3. 58 Boyd Street

4. 583-605 Stevens Avenue

7. 383 Commercial Street

**LEGAL ADVERTISEMENT
PORTLAND PLANNING BOARD
MEETING AGENDA**

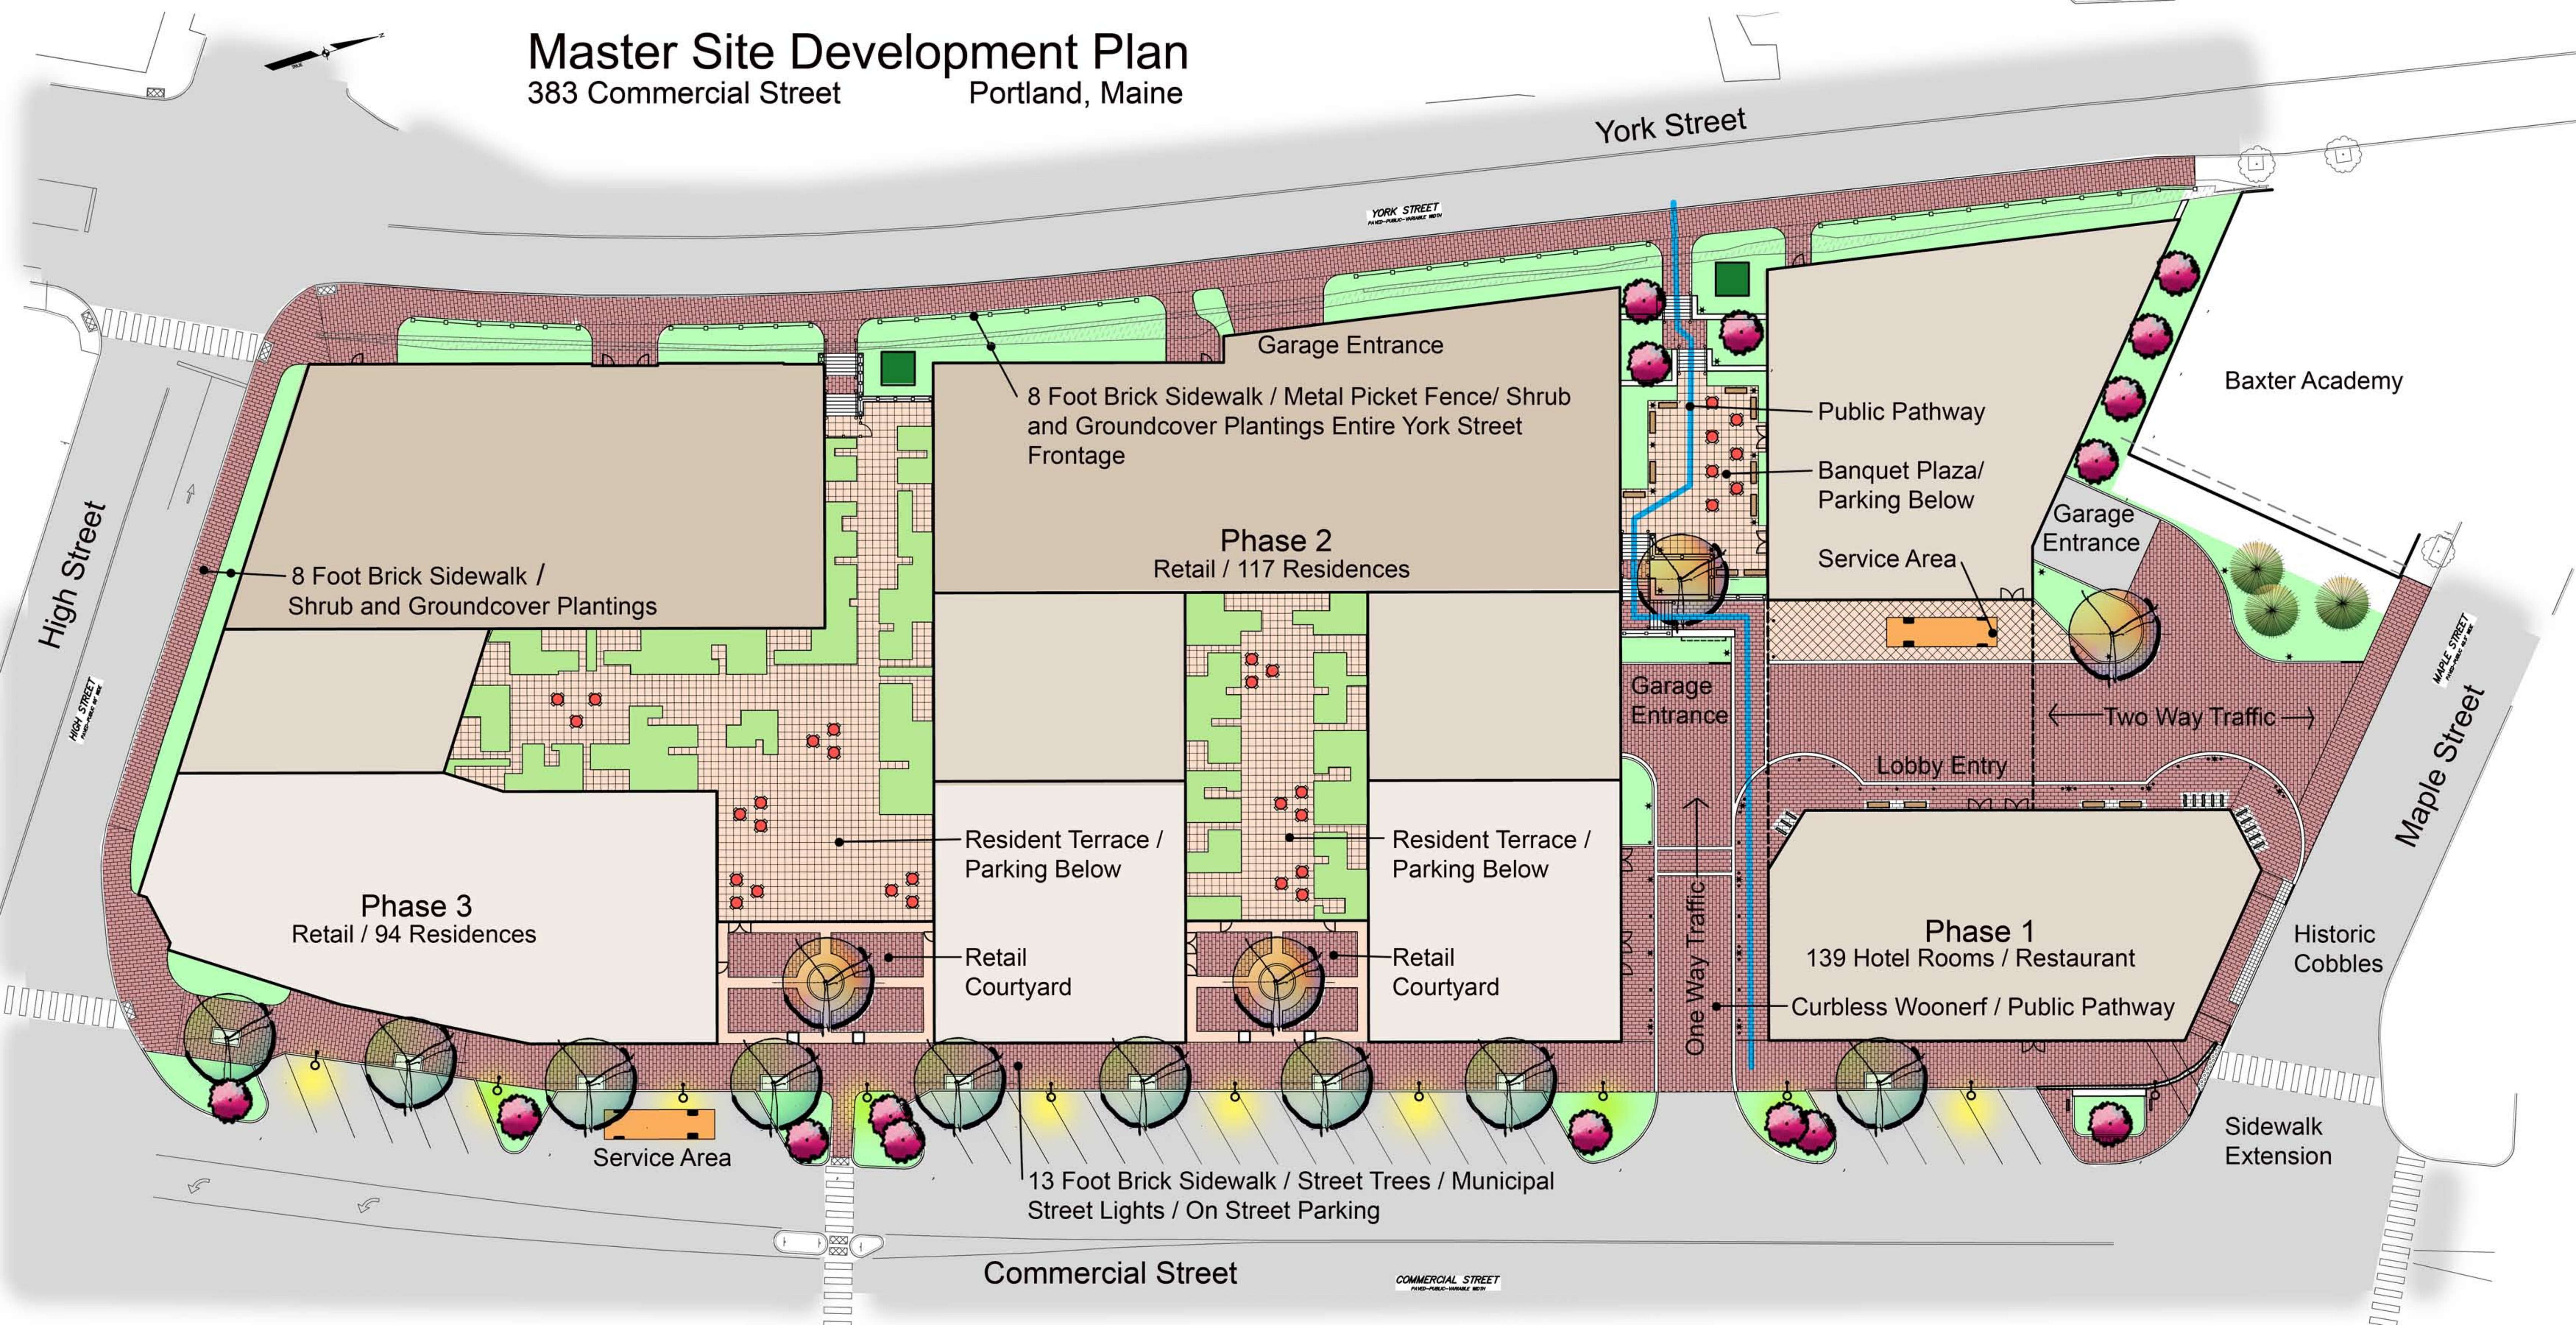
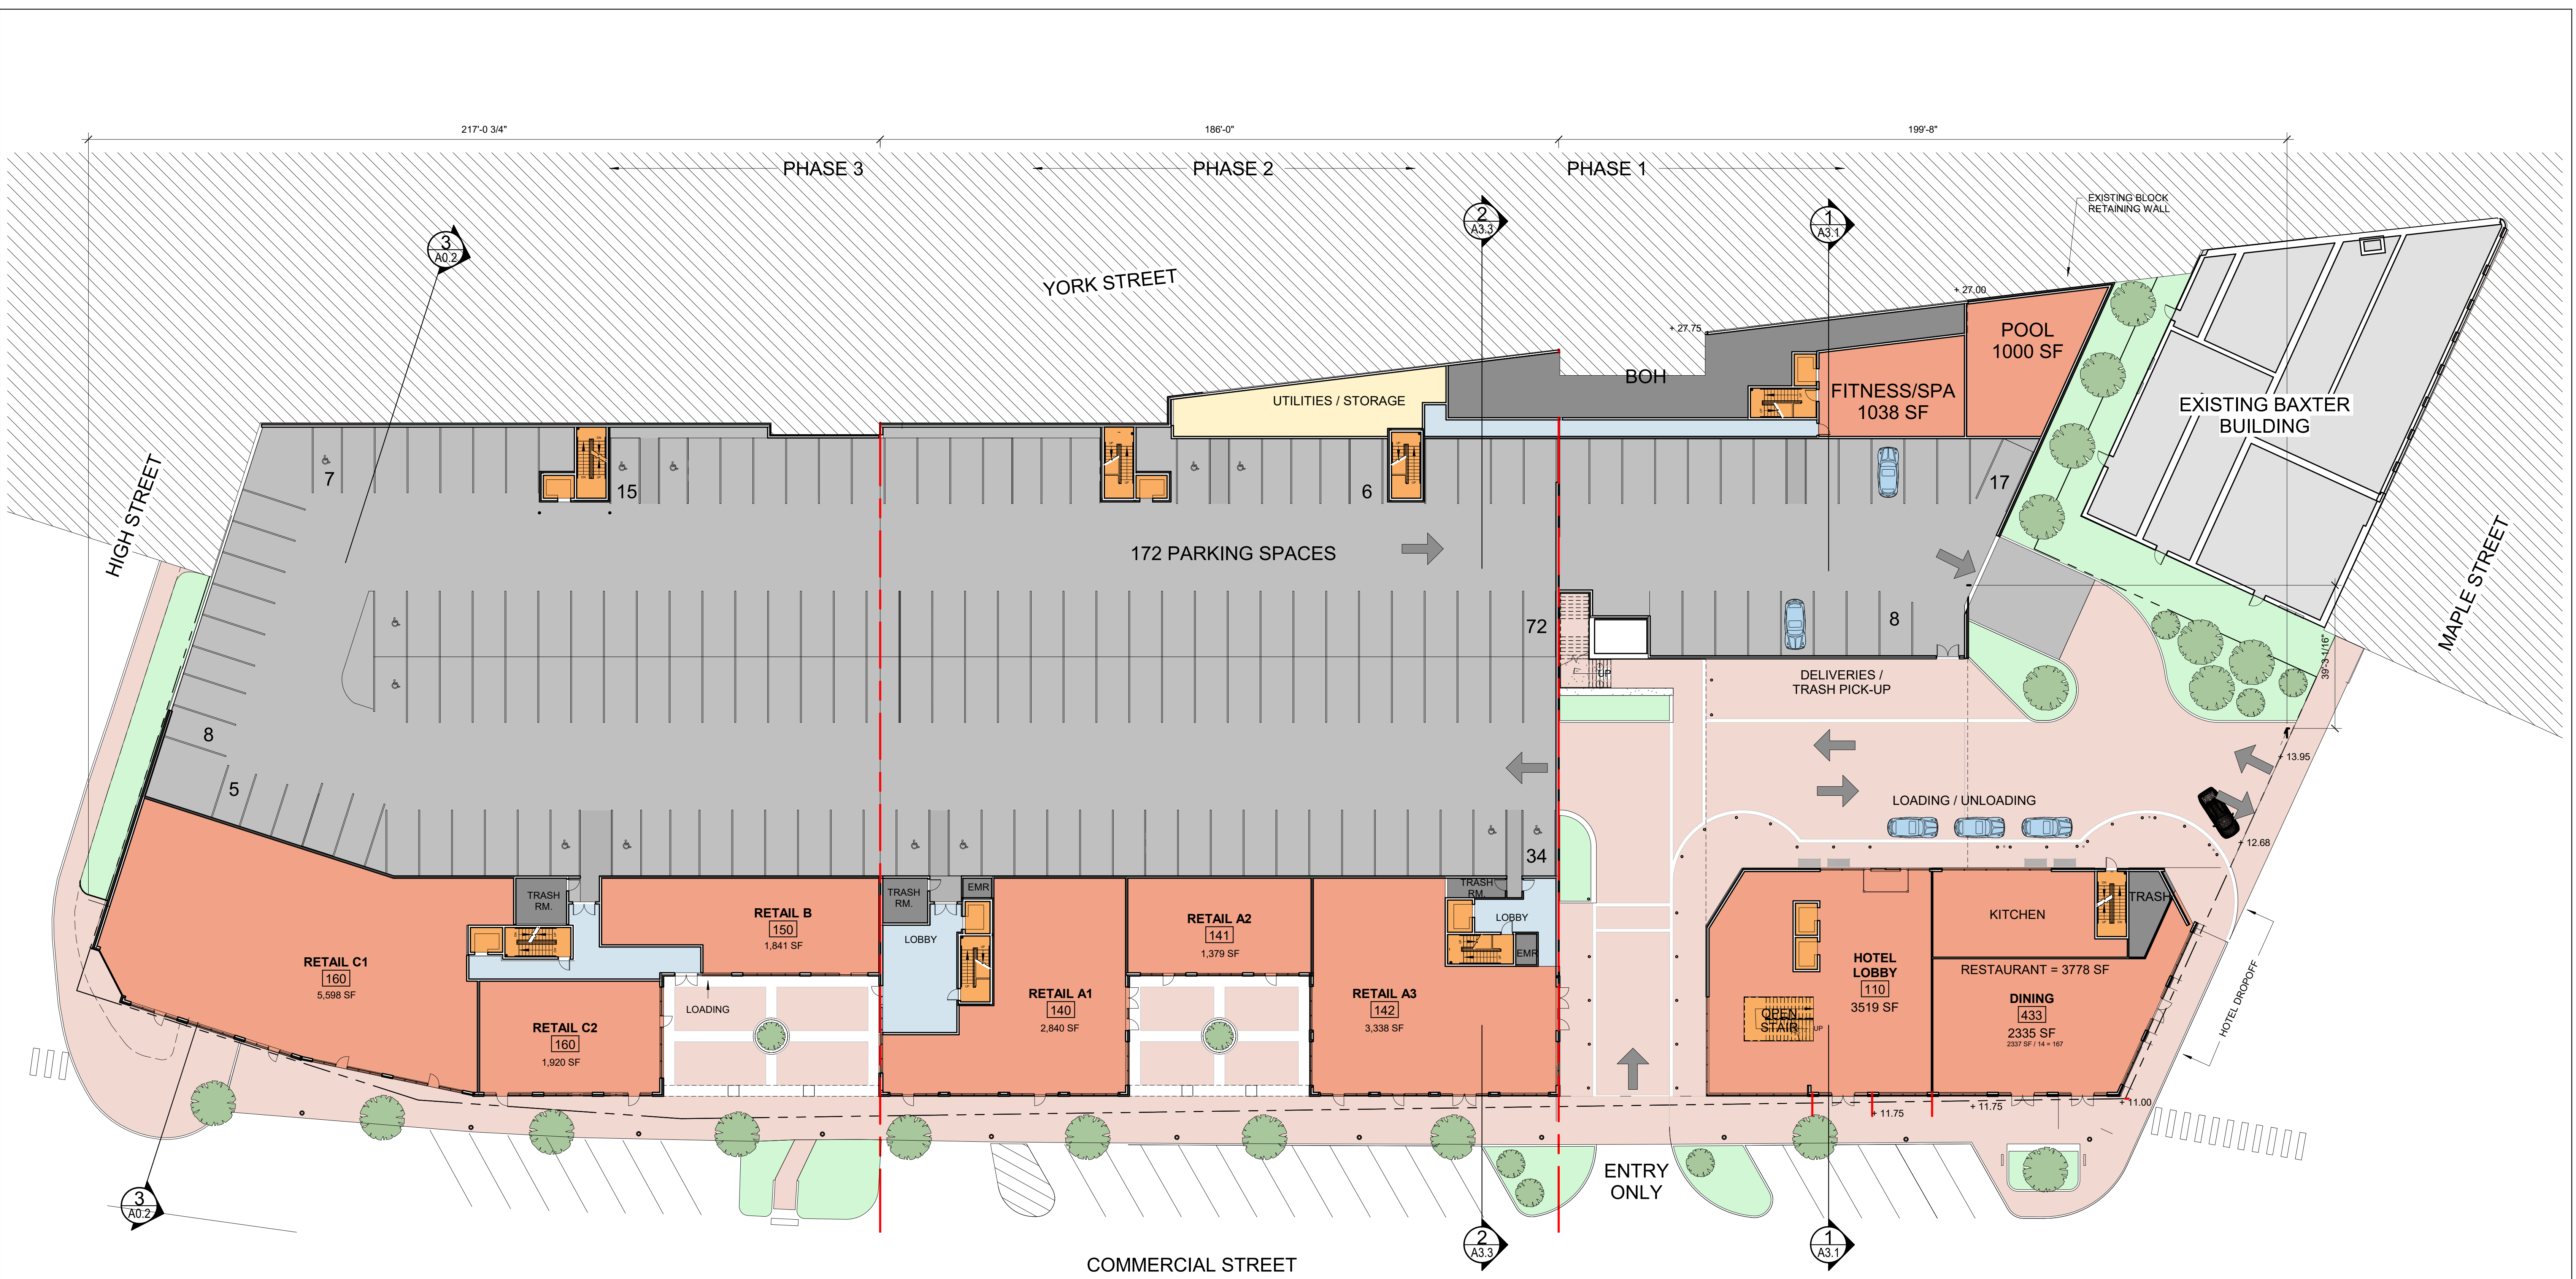
- Board members questioned the introduction of lead-coated copper in the center of the westernmost building's facade, as the change in material did not coincide with a change in building plane. As such, it appeared somewhat applied and arbitrary. By

reintroducing it on this building, it also undermined the distinctiveness of the hotel. Board members also expressed the view that the original proposal's curved façade was more successful than the faceted façade of the revised proposal and that the treatment of the western corner itself remained unresolved.

- Regarding the York Street facades of the residential buildings, Board members noted that the design solution includes a number of exterior materials to provide visual interest and variety. The Board suggested that a single building base material and consistent base height be introduced across the facades of the residential buildings to provide some level of continuity along this streetscape.
- Board members questioned the treatment of the two passageways on York Street leading to the private courtyards. They noted that while the generous width of the stairways communicated an invitation to enter the development, the fence positioned at top of the stairs would prevent access. This treatment sent a mixed message. Similarly, they noted that the treatment of the elevator towers facing York Street appeared unresolved.
